FCC Class II Permissive Change Request Letter

RE: FCC Permissive II Change Request for Company: Soundlab Technology Company Limited FCC ID: 2ATKO-BAR600II

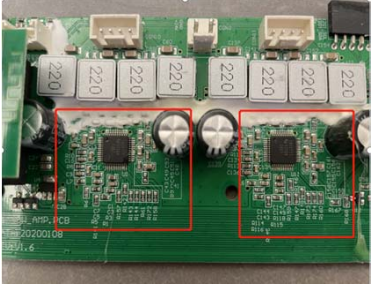
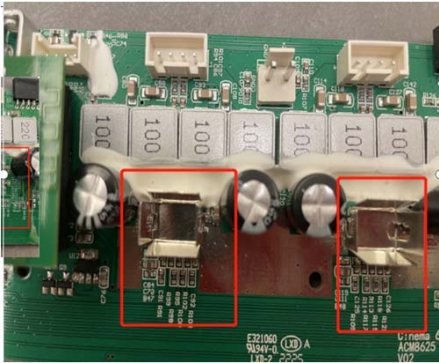
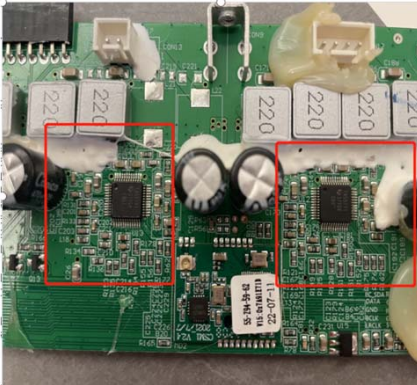
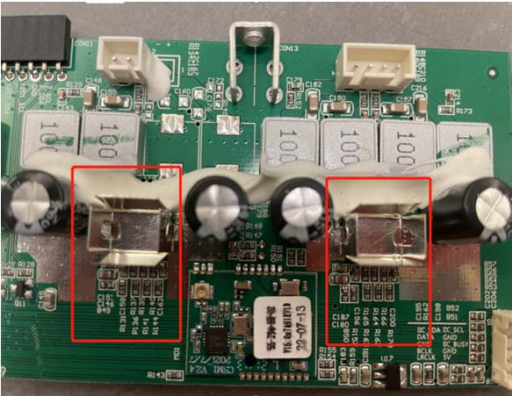
power supply board, audio amplifier IC and peripheral circuit were changed and add model number.
See the appendix

Change description	original mainboard	new mainboard
delete R12, R16, R14, R19, R10, R8, R6, R5, R141, R3, R1, R157, R142, R143, R144, R61, R172, R158, R119, R120, R112, R11, R13, R114, R116, R145, R118, R115, R159, R147, R146, R148, R173, R174, R160, R167, R168, C31, C55, C29, C25, C27, C57, C21, C23, C19, C13, C23, C15, C11, C9, C7, C5, C1, C3, C43, C49, C53, C41, C45, C51, C48, C138, C148, C153, C151, C1 add C87, C95, C105, C82, C77, C99, C83, C85, C84, C78, C91, C92, C120, C117, C116, C122, C139, C138, C129, C119, C111, C126 R91, R99, R98, R95, R100, R102, R103, R109, R114, R117, R113, R119, R118, R121.		
delete C205, C215, C2183, C220, C218, C209, C199, C200, C201, C203, C202, C211, C206, C207, C198, C210, C26, C214, C216, C225, C226, C224, C222, C229, C228, C223, C125, C172, C182, C180, C187, C185, C195, C190, C196, C176, C165, C174, C164, C173, C167, C169, C177, C168, C166, C178, C181, C183, C192, C191, C193, C189 R137, R139, R140, R132, R131, R133, R134, R136, R135, R153, R138, R57, R154, R178, R155, R156, R165, R177, R62, R63, R56, R127, R129, R130, R122, R103, R180, R121, R123, R124, R126, R149, R125, R128, R161, R151, R152, R175, R176, R162, R150. add C152, C154, C150, C171, C163, C157, C170, C164, C177, C151, C146, C158, C162, C188, C185, C184, C194, C201, C213, C212, C204, C187, C180, C196, C200 R148, R147, R131, R137, R136, R135, R141, R140, R144, R150, R151, R163, R165, R157, R166

delete U1, U11, U13, U12 (IC MODE:TAS5731) add: U13, U14, U15, U16 (IC MODE:ACM8625)
